UNITED STATES PATENT AND TRADEMARK OFFICE

10/551,089

Office Action Summary	Application No. 10/551,089	Applicant(s) DI GIACOMO ET AL.	
	Examiner NURI ALTUN	Art Unit 3657

DETAILED ACTION

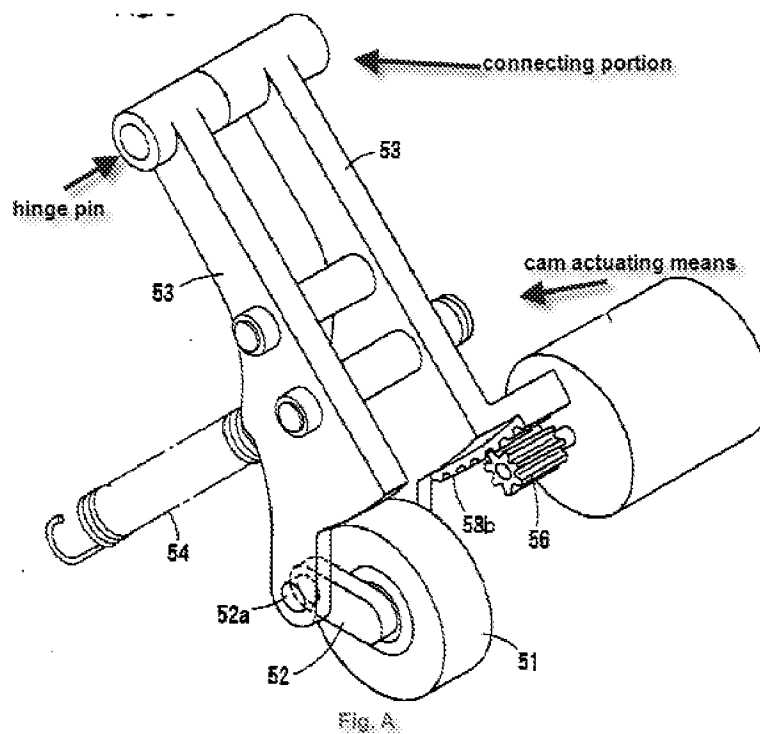
As per claims 4-8, Temma et al. teach a mechanical drive (56 and 53b) interposed between said actuating means and said movable supporting member (53) (Claim 4), movable supporting member comprises a connecting portion, opposite the drive wheel, connected to mechanical drive, to move along a circular trajectory (see Fig. A) (Claim 5), and said mechanical drive comprises a gear drive (56) interposed between the electric rotary motor and said movable supporting member (claim 6), and mechanical drive comprises cam actuating means (see Fig. A) (Claim 7) interposed between said gear drive and said connecting portion (see Figs. A) (Claim 8).

Temma et al. teach said connecting portion is a hollow tubular portion having an axis of symmetry parallel to the axis of rotation of said drive wheel (51) (see Fig. A); and in that said cam actuating means comprise a hinge pin engaging said hollow tubular
